# HISTORIC LANDMARK COMMISSION STAFF REPORT

**McDonald's  
New Construction  
PLNHLC2013-00499  
242 South 700 East  
August 1, 2013**

McDonald's, represented by Darrin Perkes, requests approval to construct a McDonald's restaurant at approximately 242 South 700 East. The demolition of the existing building on the site is proposed.

**Attachment A  
Site Plan/Elevations**

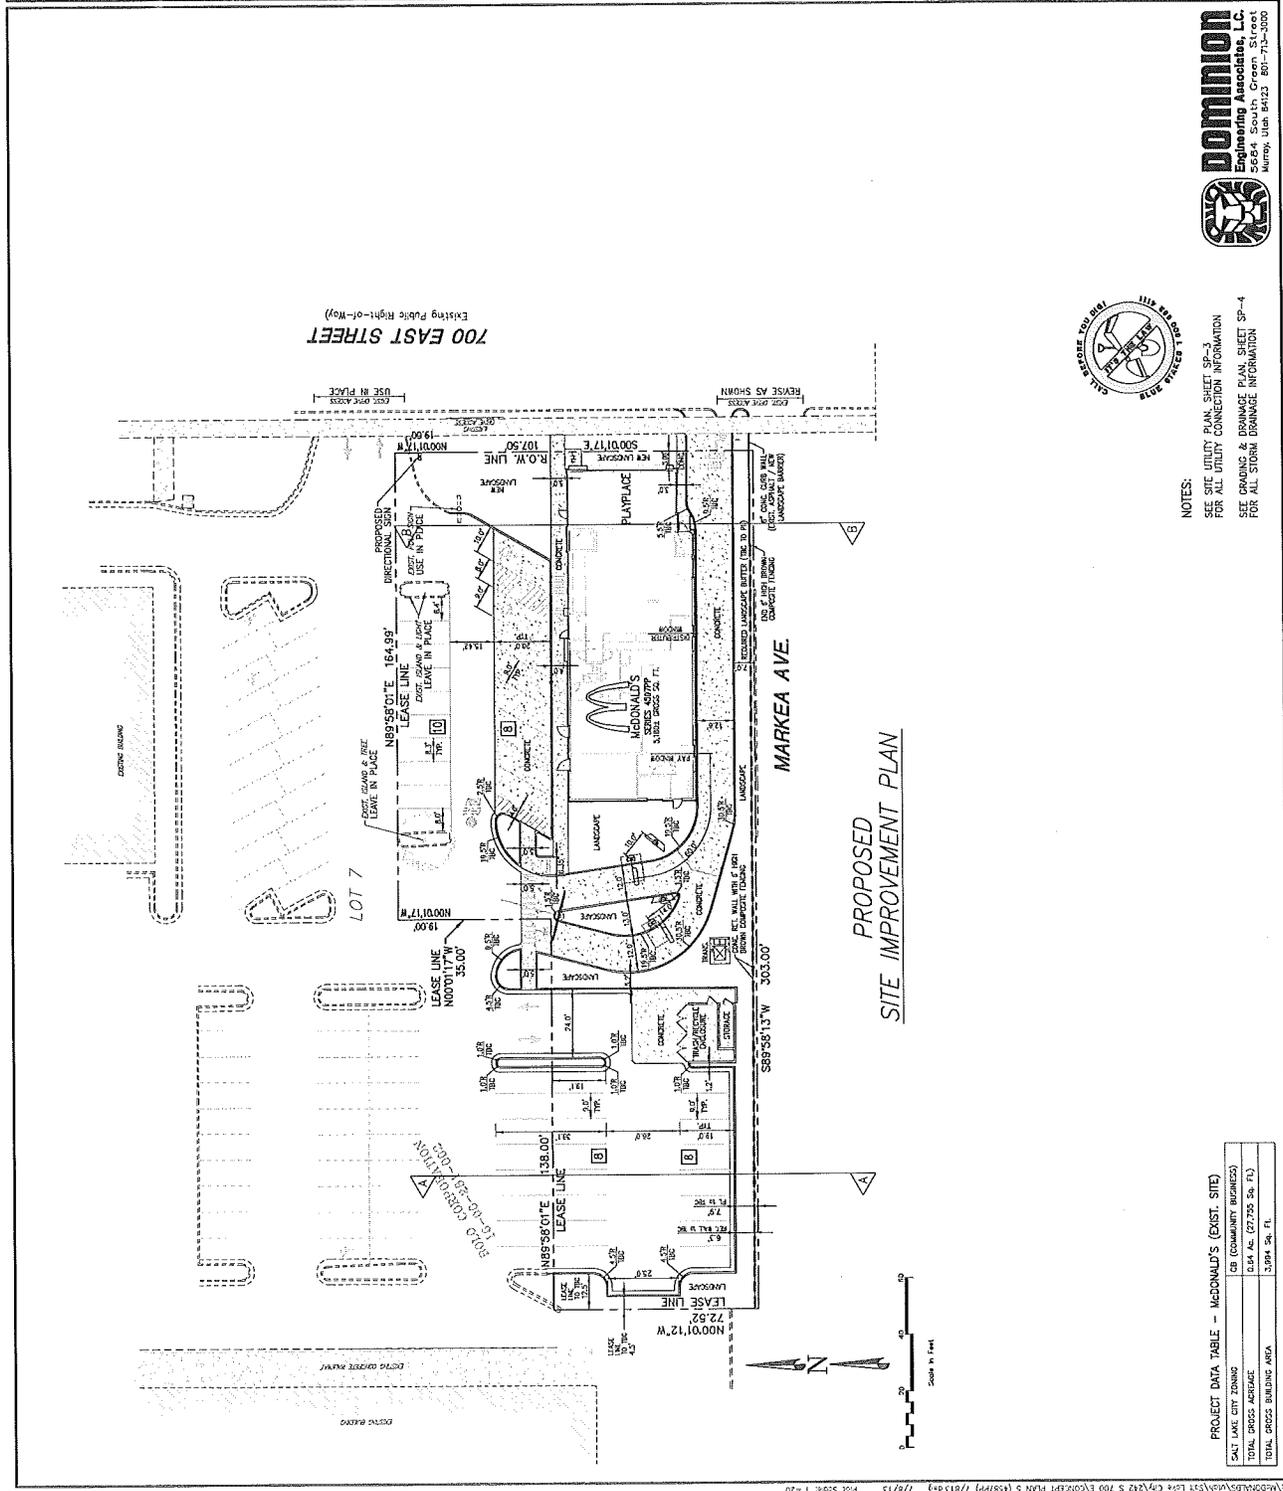
Staff has reviewed this project and met with the applicant to discuss the design of the project. Staff has expressed concerns about the proposed use of a standing seam metal roofing material to cover the barrel arch, the location of the front entrance, and the proposed use of synthetic stucco (EIFS) for a portion of the exterior wall cladding.

- **Maximum Length:** The maximum length of any blank wall uninterrupted by windows, doors, art or architectural detailing at the first floor level shall be fifteen feet (15'). *The building design is inconsistent with this requirement.*

**Finding:** The final site and building design shall comply with the code requirements mentioned above which will be verified prior to building permit issuance. Staff finds that the building design fails to meet the “maximum length of any blank wall” standard of the ordinance.

The Commission should carefully consider whether synthetic stucco systems are an appropriate substitute material for traditional stucco cladding. Moisture problems may arise if installed incorrectly. In addition, standing seam metal roofing systems were typically not used historically in the districts. The Commission should consider if the proposed roofing material is appropriate for the design. Because of the high visibility of each facade of the building, staff also suggests a base be integrated into the composition of the wall to anchor the building to the ground and add visual interest to the design.

**Finding:** The project is generally consistent with this standard. Nonetheless, staff finds that improvements to the design could be made such as using a traditional stucco material, relocating the front entrance, providing a distinguishable solid base to the building, and changing the roofing material of the barrel arch.

1. Approval of the final details of the design including roofing and wall materials shall be delegated to the Planning Staff based upon direction given during the hearing from the Historic Landmark Commission.
2. The project must meet all other applicable City requirements, unless otherwise modified within the authority of the Historic Landmark Commission.
3. The property owner shall make efforts to salvage any architectural features and building materials that will be removed.
